Subject: WATER IN THE INSTRUMENT AIR LINES AT THE CONDENSATE POLISHER CONTROL PANEL AND REGENERATION SKID RESULTING IN A LOSS OF FEEDWATER CONDITION IN UNIT #2 ON OCTOBER 19, 1977

Location TMI Nuclear Station
Middletown, PA 17057
Date November 14, 1977

FIELD QUESTIONNAIRE NO. 1577

SERIAL NO. S-4562
DISCIPLINE Mech
SUBJECT S.A. to Cond. Polisher
ATTACHMENTS 2

Attachment 1 of 2
 ECM No. S-4512

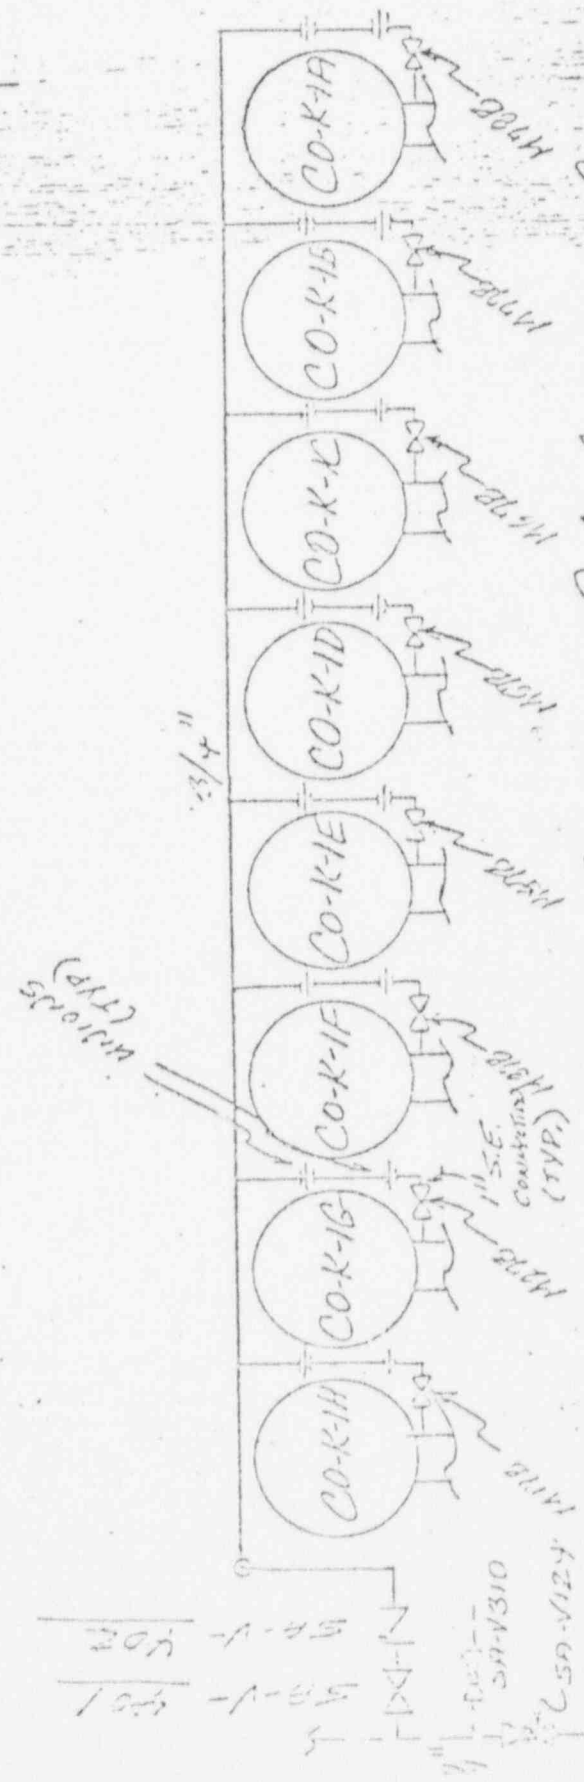
UEC START-UP TO CONNECT 3/4" Line spec.
150-1, piping at S.A. STA. NO. 12 and field
route to a 3/4" C.S. gate valve and check valve.
From the check valve field run the header
and branch lines to each Condensate Polisher
valve M17B then M87B. (see attachments
1 and 2 of 2).

GPU Request to provide permanent S.A.
supply to the bottom of each Condensate
Polisher to lift & fluff resins prior to sluicing
to Regeneration Station.

All Piping To Be 3/4" ISO-1
 And Field Run By UEC STARTUP
